June 30, 2009

RE: MEDINA SUPPLY
3GR01050*DG
STORMWATER
SUMMIT COUNTY

Fig. 1: Floating material near outlet of northwest pond

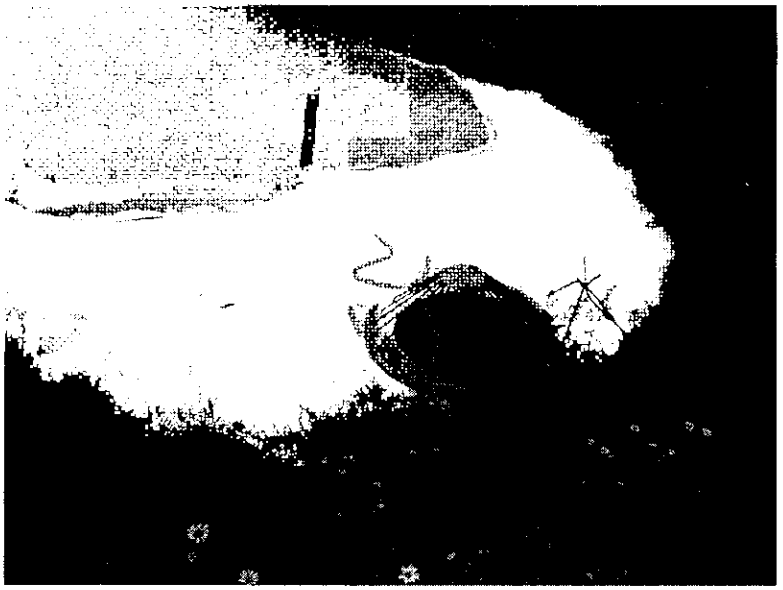
2. At the time of the inspection, a considerable amount of floating material had collected around the northwest pond outlet. A picture is attached for your reference. The larger outlet pipe was conveying water from below the pond level and was not allowing the floating material to exit the pond. When the pond level drops this material could be discharged. It was recommended that a floating baffle be installed to keep this material in the pond.

1) Clean out the 2" pipes plugged in the outlet manhole for the northwest pond.
2) Submit an updated SWPPP with the above listed items adequately addressed on or before July 23, 2009 as required by the General permit.
